RESPONSES TO THE NUCLEAR REGULATORY COMMISSION
REQUESTS FOR ADDITIONAL INFORMATION
DELAVAL DIESEL GENERATOR EVALUATION
CATAWBA NUCLEAR STATION UNITS 1&2

PREPARED BY
DUKE POWER COMPANY
FEBRUARY 9, 1984

FIGURE 2

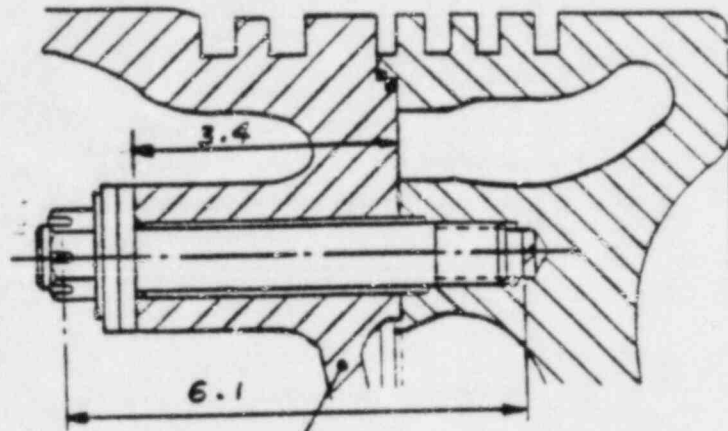
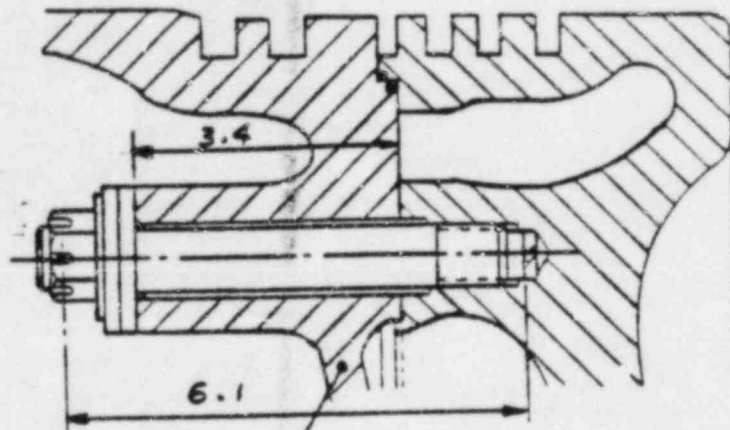
1. "AF" Pistons, refer to figure 2.

- A. Heat to 1750 degrees F. (near the upper critical temperature) for 3 hours. Normalized (air cooled) in still air. Result: a pearlitic structure and 100,000 psi tensile strength.

- B. Re-heat to 1050 degrees (slightly below the lower critical temperature) for 3 hours and cool in still air. This is a tempering process used to produce the desired ductility in the nodular iron.

SKIRT
03-341-02-AN (OLD STYLE - MADE FROM
03-341-02-AN CASTING)

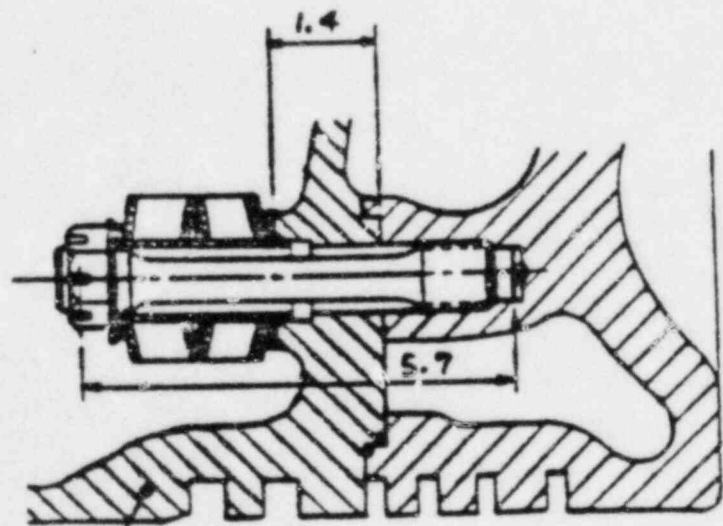
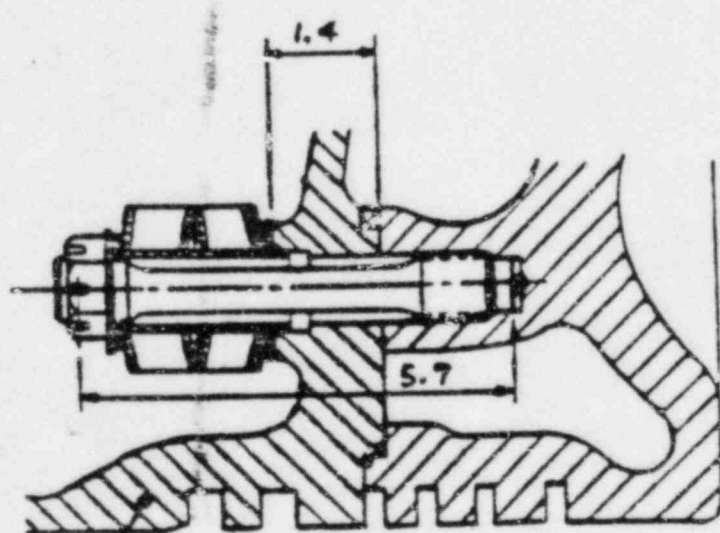
2. "AN" old style, refer to Figure 3.

This is the skirt design used in all other TDI nuclear standby diesel engines except the recent SMUD and CP&L engines which use the current AE skirts.

FIGURE 4

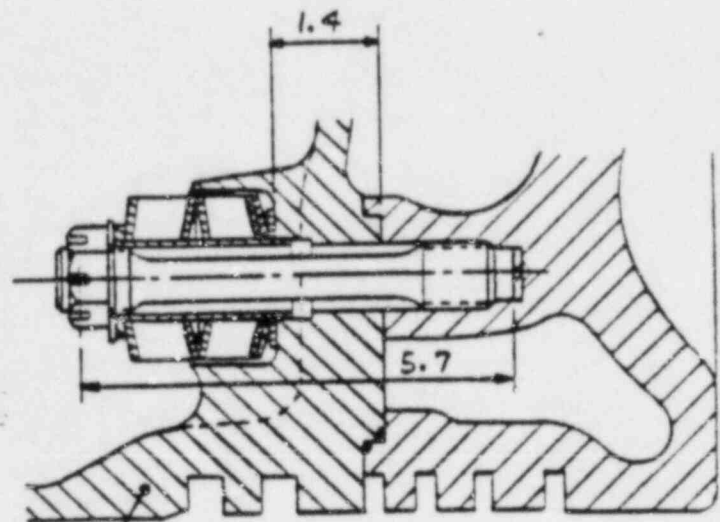
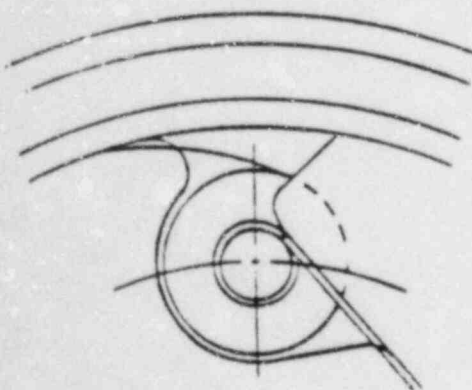
3. "AN" New Style, Refer to Figure 4.

FIGURE 5

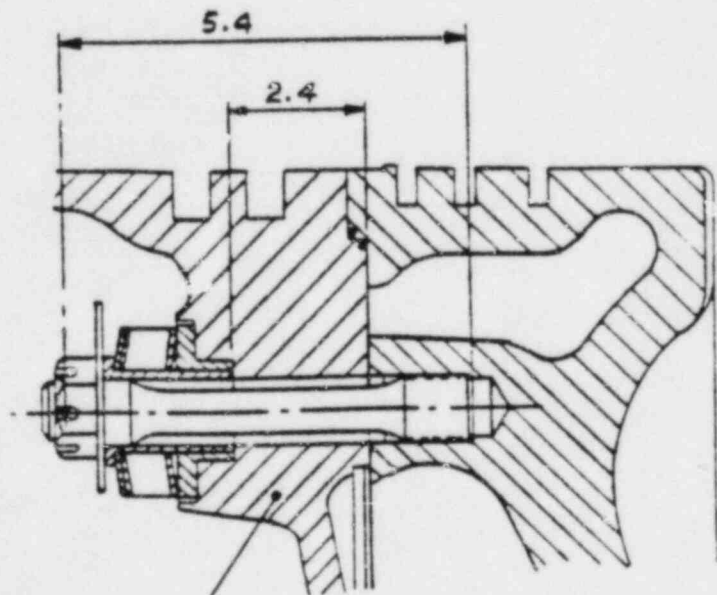
4. "AE", Refer to Figure 5.
